Gate Study

3.1 Consented & Proposed- Plan Views

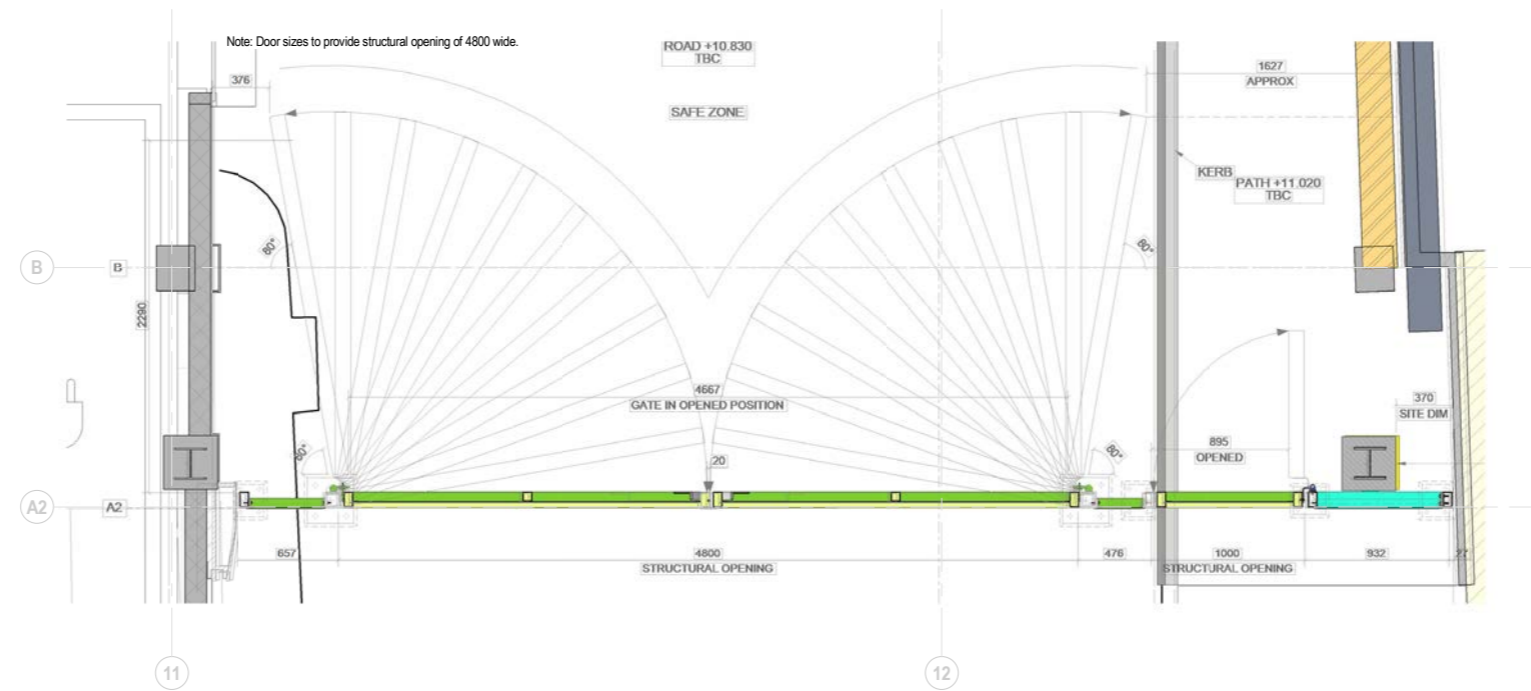
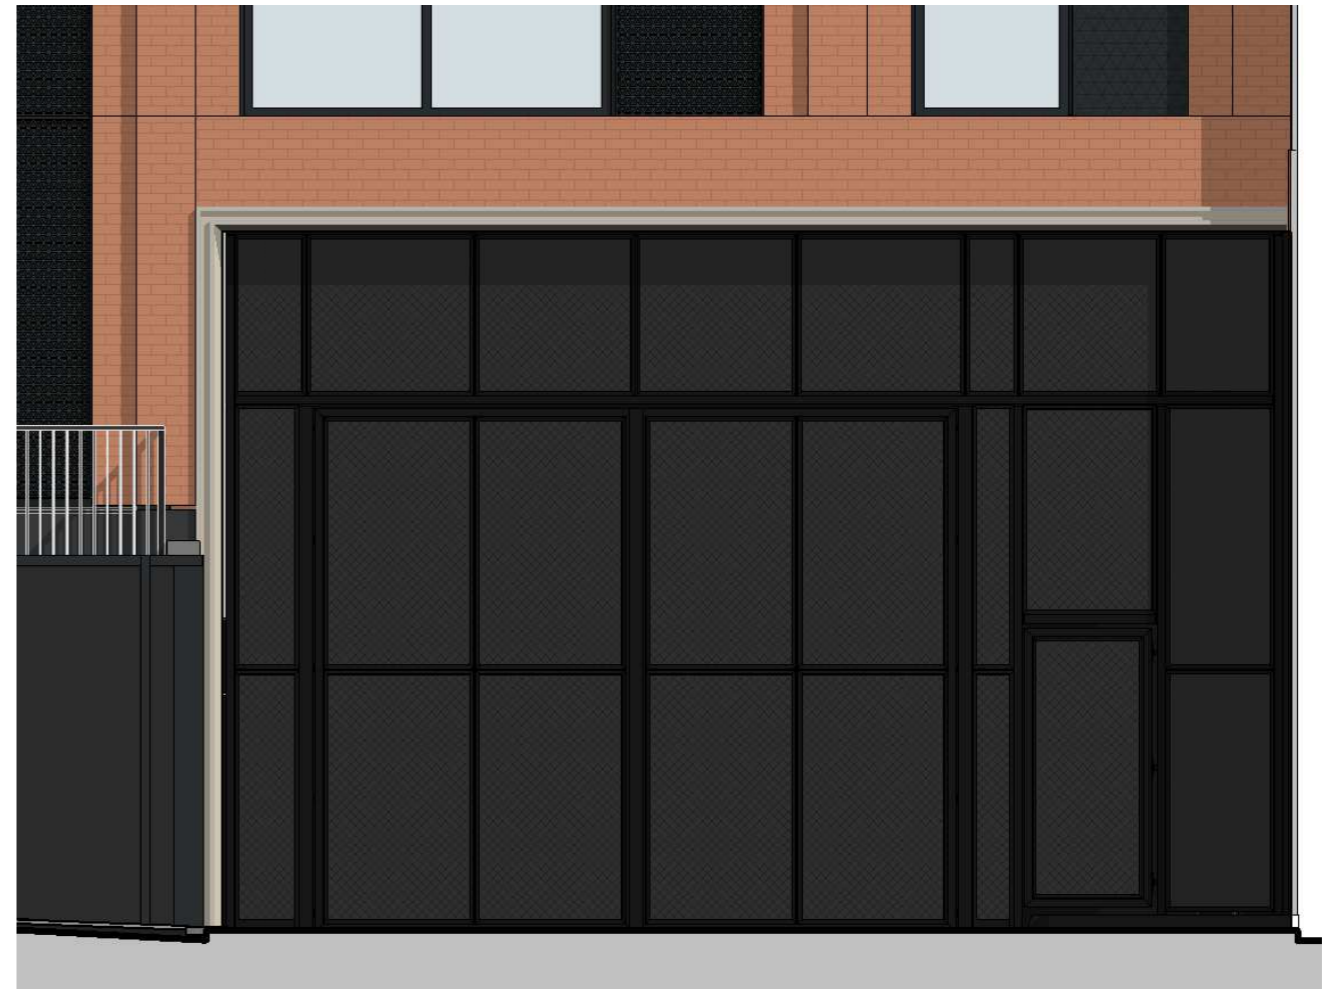
- Cycle entrance adjusted to more accessible location and independent from main gate
- Gate width increased for improved waste management access
- Gate support posts refined
